ACP-2021-078

**Enabling Remotely Piloted Aircraft Operations from RAF
Fairford**

**Post-Implementation Engagement on Proposed Change
to EGD218**

Figure 2 Proposed Change to EGD 218 Complex

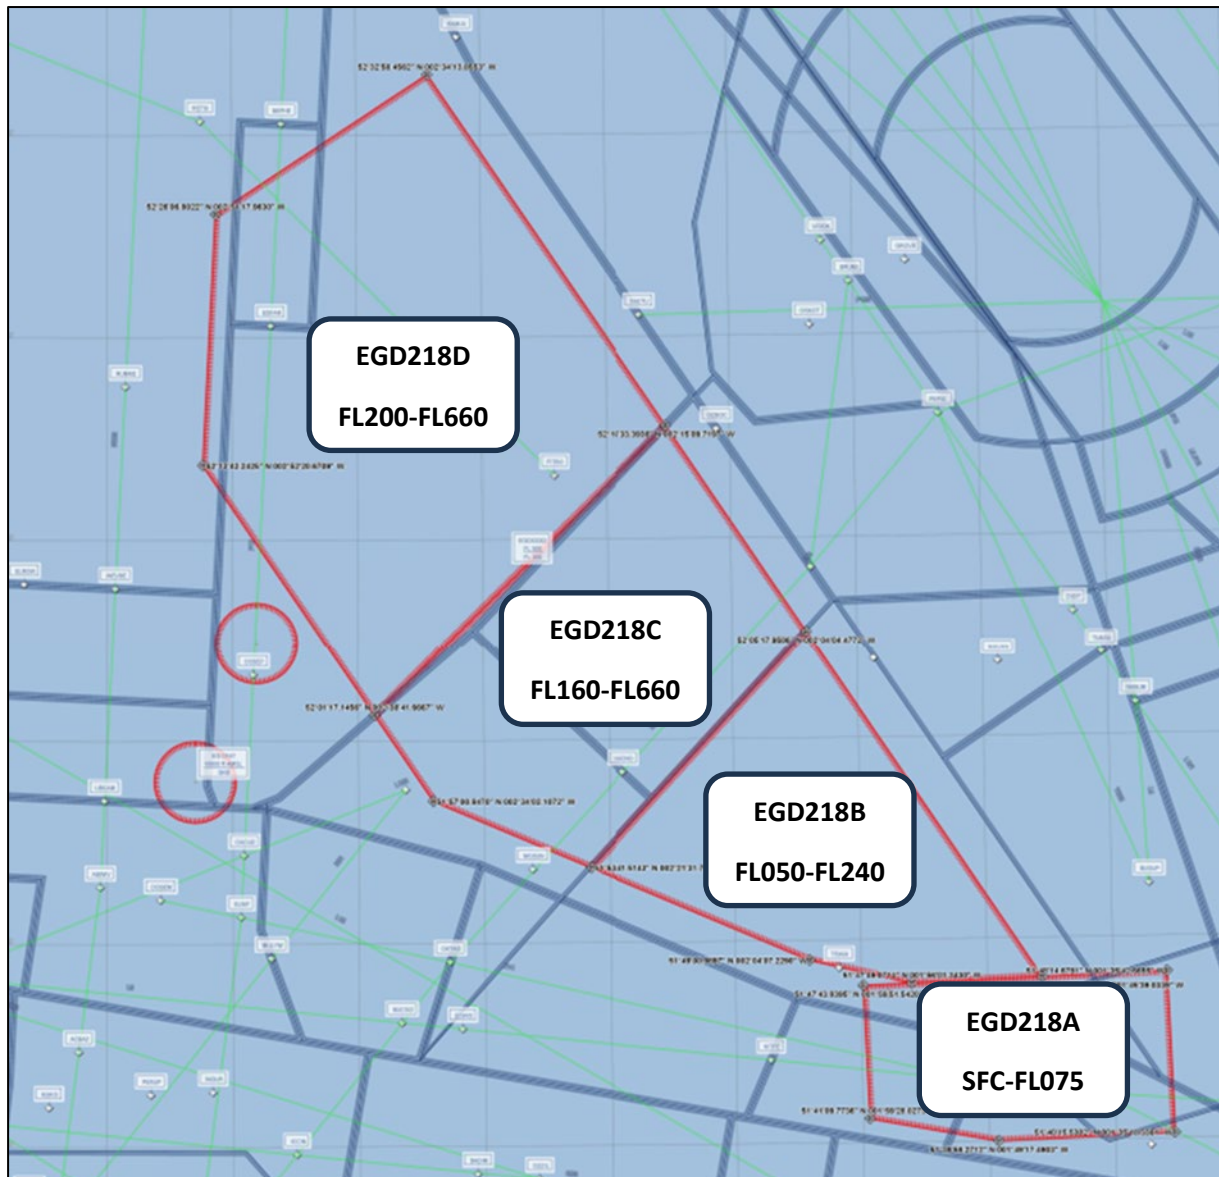
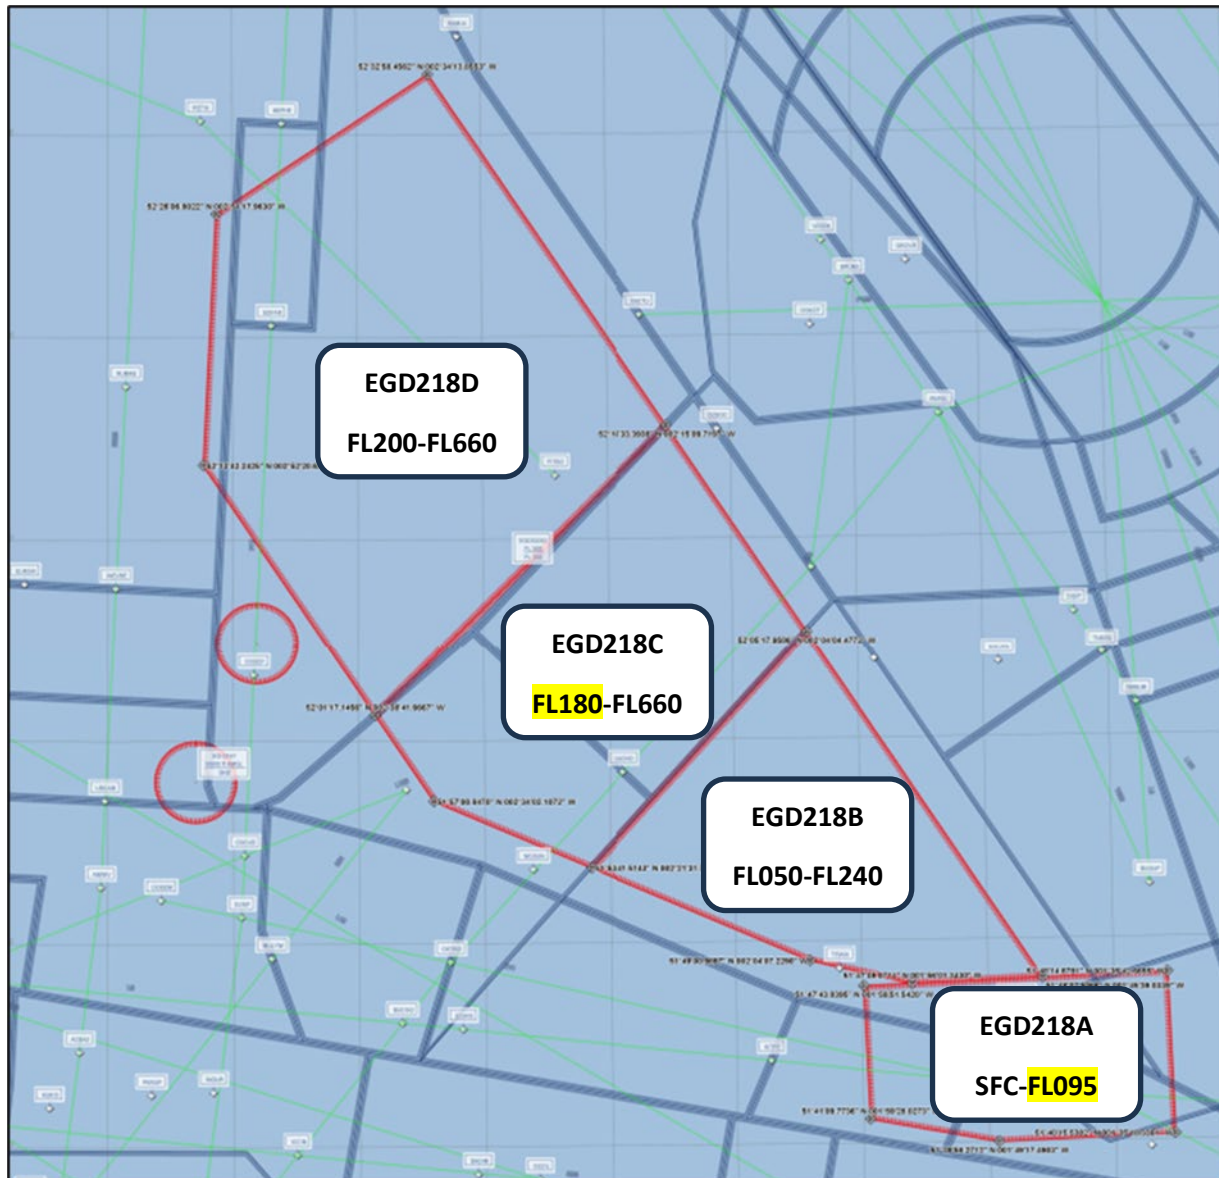
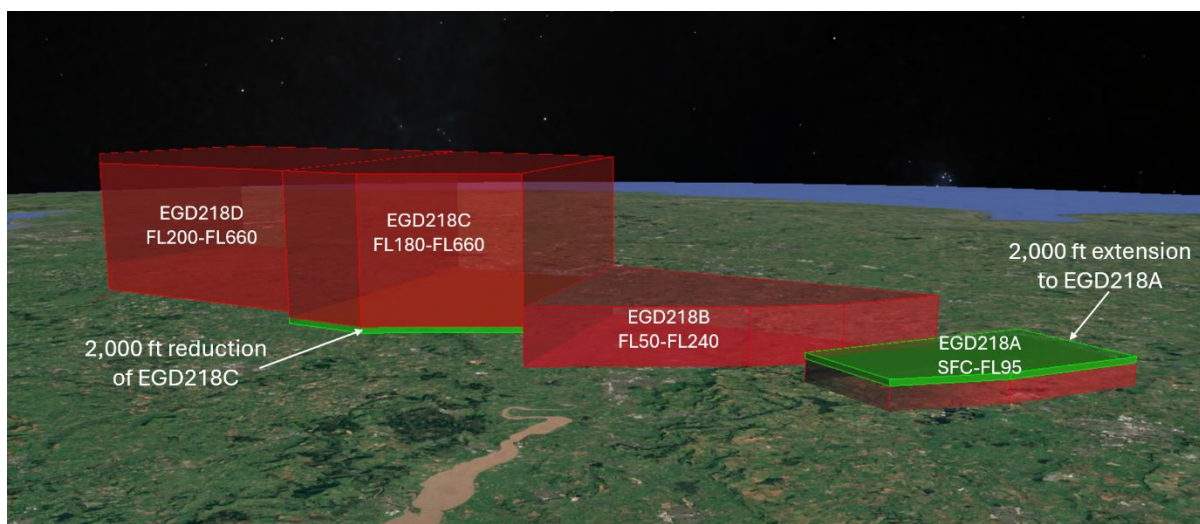
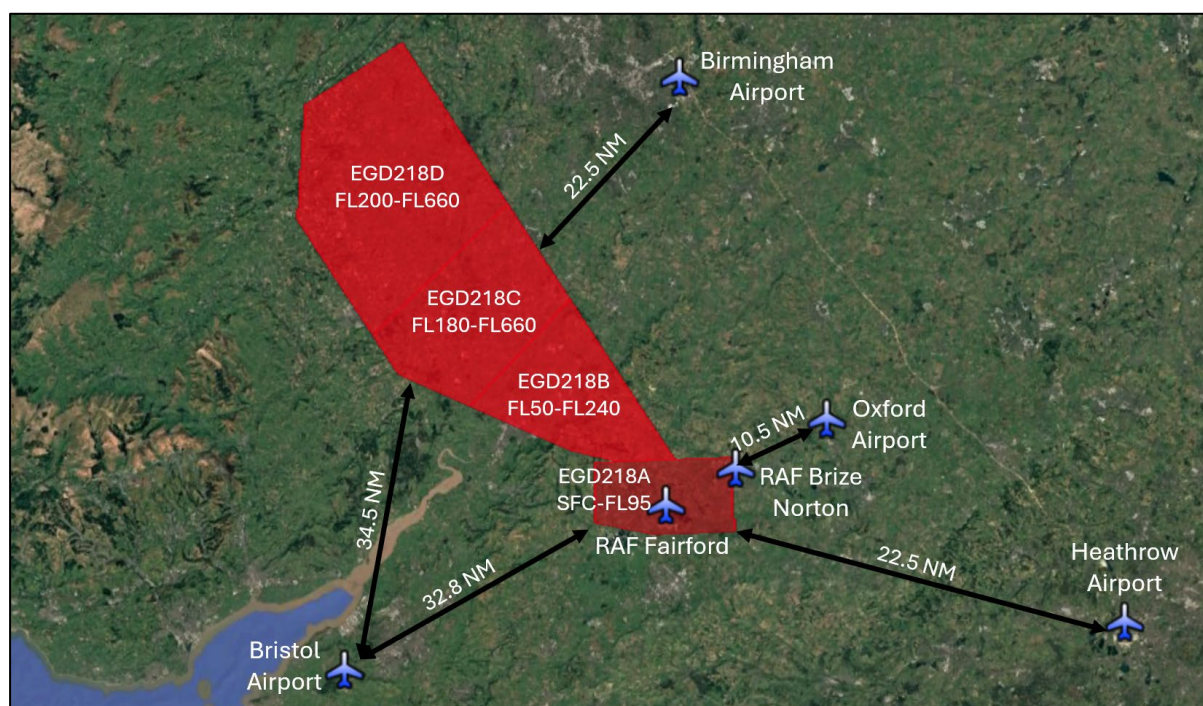
The lateral dimensions of the EGD218 complex are to remain unchanged. The proposed modification only raises the floor of EGD218C from FL160 to FL180 and raises the ceiling of EGD218A from FL075 to FL095.

Raising the floor of EGD218C should not have additional impacts as that volume of airspace is being reduced. Raising the ceiling of EGD218A from FL075 to FL095 does have the potential for unintended impacts as the volume is increasing vertically. The purpose of this engagement is to gather input from any stakeholders that expect this change to impact their operations.
